REMARKS

Serial No. 09/695,704
 Amendment Dated Aug 15, 2003
 Annotated Sheet Showing Changes

FIGURE 1.2 B

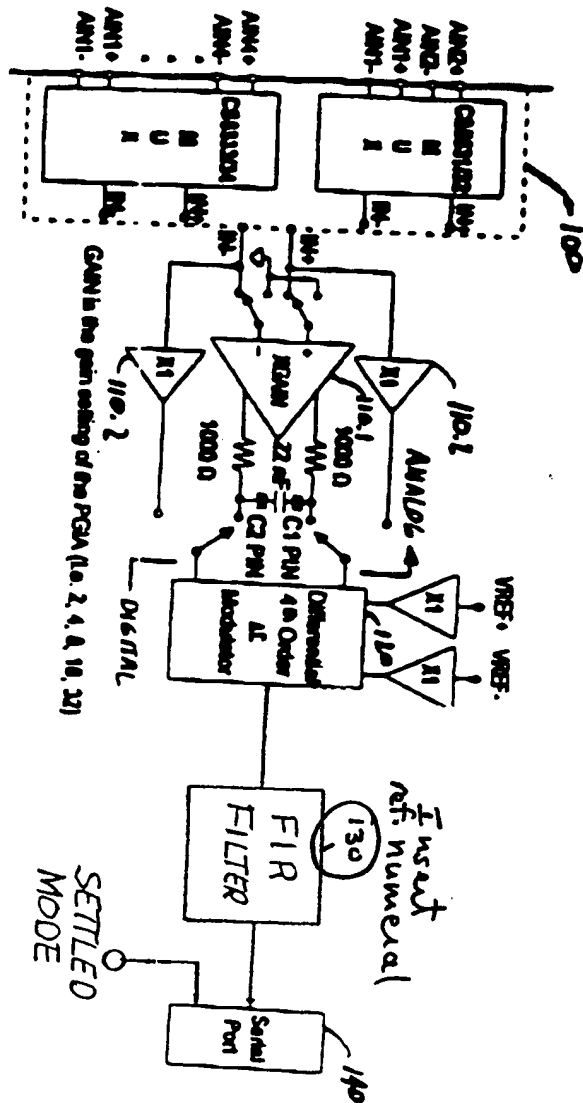
The drawings have been objected to as failing to comply with 37 C.F.R. §1.84(p)(5) because they include reference signs not mentioned in the Description. The Applicants have filed concurrently herewith corrected drawings deleting reference signs not mentioned in the Description. Also, as noted hereinabove, formal drawings have been filed to replace the informal drawings previously submitted.

FIG 1.2c
(Prior Art)
Insert

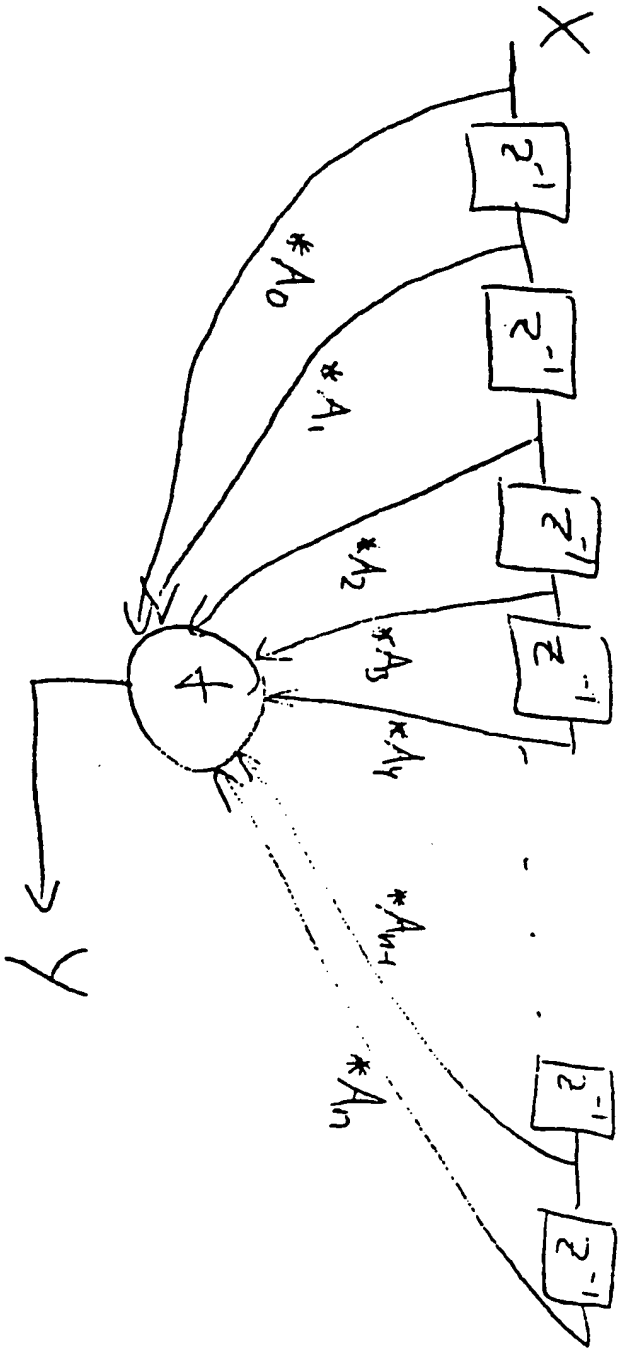
Additionally, Figures 1.2(C) and 1.4 were objected to as failing to include a legend such as "Prior Art." New Figures 1.2(C) and 1.4 have been filed concurrently herewith bearing the legend "Prior Art."

Figure 1,4
 (Prior Art)
 Insert

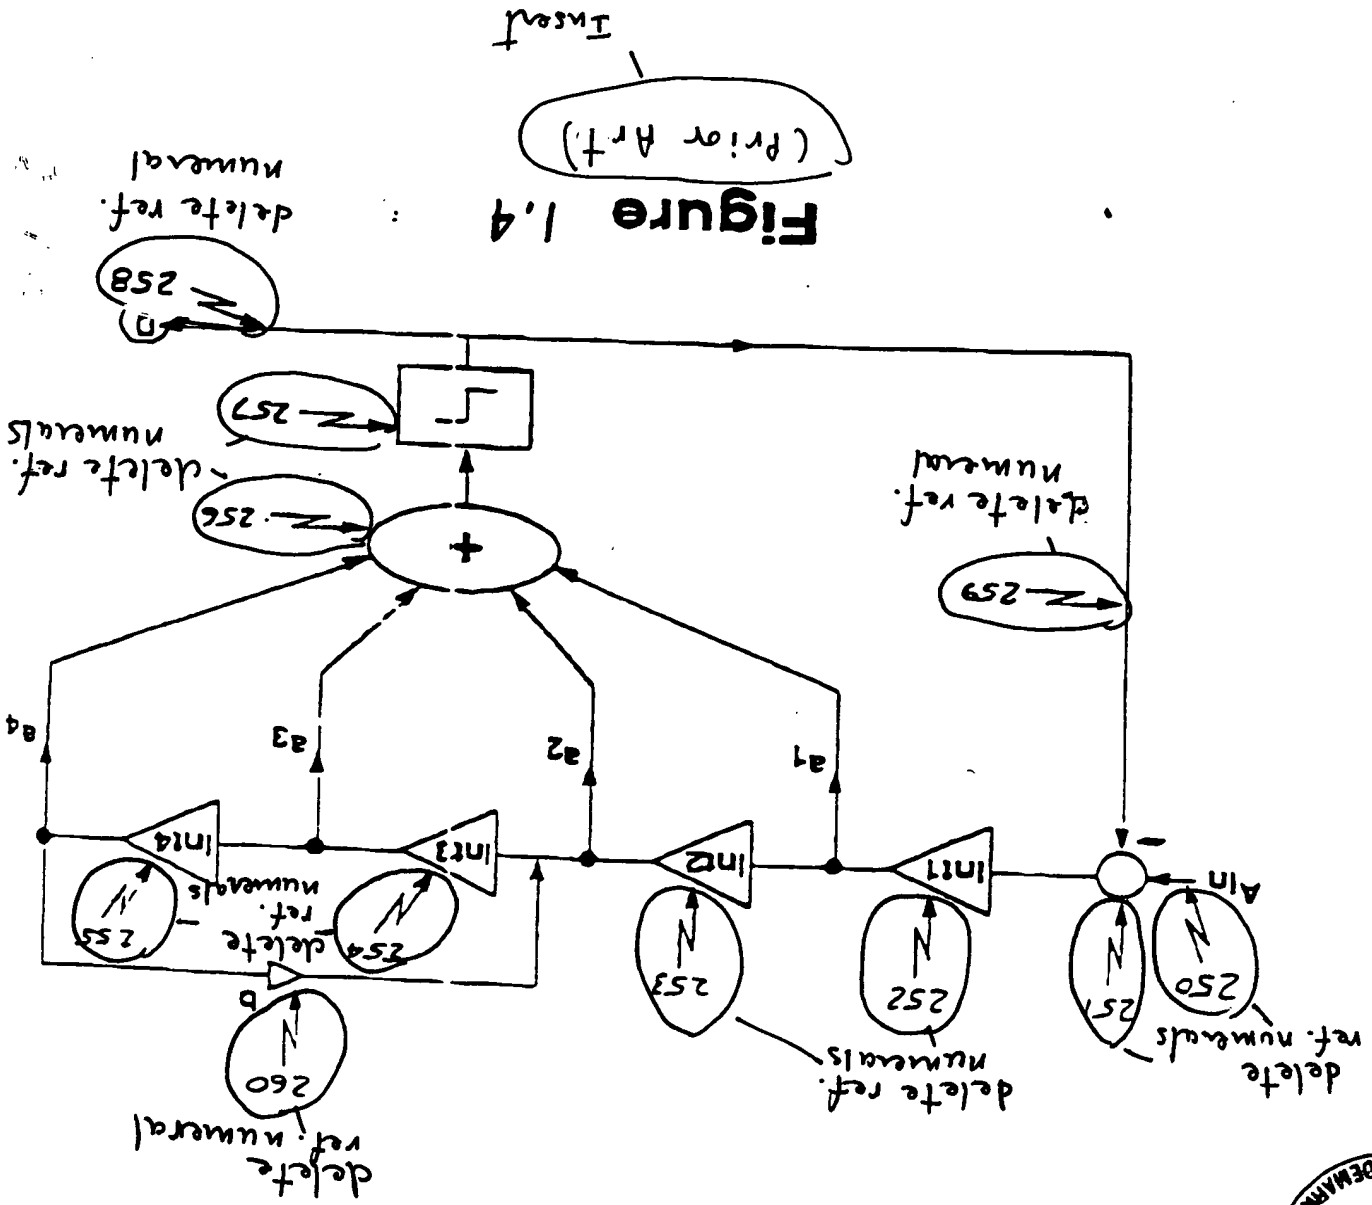
delete title

Figure 1.5A

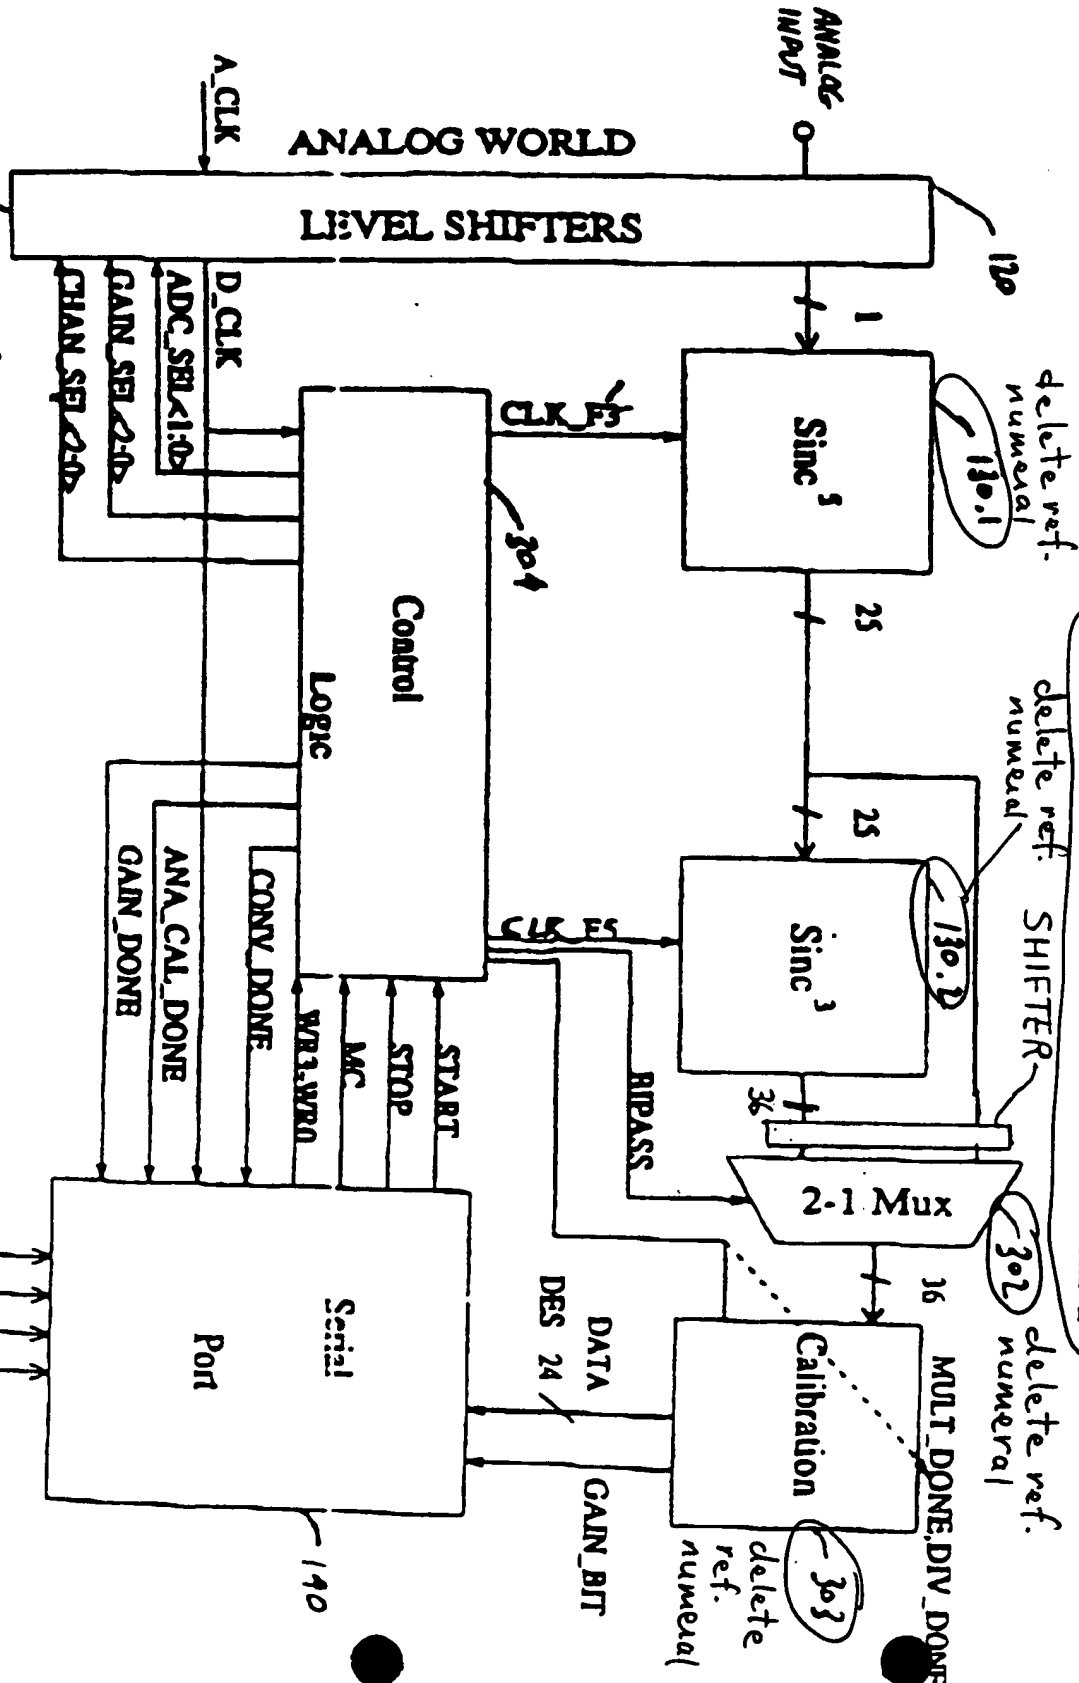
The Examiner has also asserted that Drawings 1.2A, 1.2B, 1.3 and 1.5X have not been mentioned in the Specification. The Applicants note that there is no Drawing 1.5X. The Applicants understand that the reference to Figure 1.5X should be 1.5A. The Applicants also note that Figure 1.2A is referred to on page 6 at line 23. Likewise, Figure 1.2B is referred to on page 6 at line 28 and on page 7 at line 10. Figure 1.3 is referred to on page 7, at line 13. Figure 1.5A is discussed on page 8 at line 17.

delete title
